Reverse Gate Adjustment - Sport Jet 175 XR²

All Sport Jet 175 XR² Models

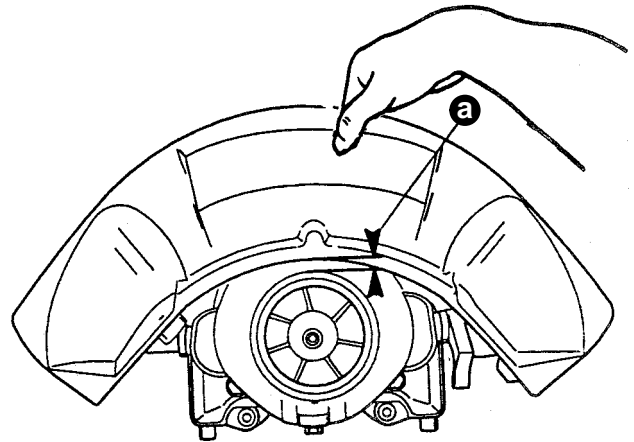
We have received reports from the field of failed reverse gate stops. Review of these failures indicate the cause was due to improper adjustment of the shift cable. If the lower edge of the reverse gate is not 3/8" (9.5 mm) to 1/2" (12.7 mm) above the edge of the steering rudder after removing the shift cable slack in the forward position, damage to the stops and reverse gate may occur.

To check shift cable adjustment, first shift the remote control lever into the forward position. Apply a light downward pressure on the reverse gate until all slack is removed from the shift cable. While maintaining the downward pressure to remove the cable slack, measure the distance between the lower edge of the reverse gate and the upper-most portion of the steering rudder (dimension "a" in figure below). This dimension should be between 3/8" (9.5 mm) to 1/2" (12.7 mm). If the clearance is less than 3/8" (9.5 mm), readjust the shift cable as outlined in the installation manual (P/N 90-10164970) or the service manual (P/N 90-852396).

a - 3/8" (9.5 mm) to 1/2" (12.7 mm)
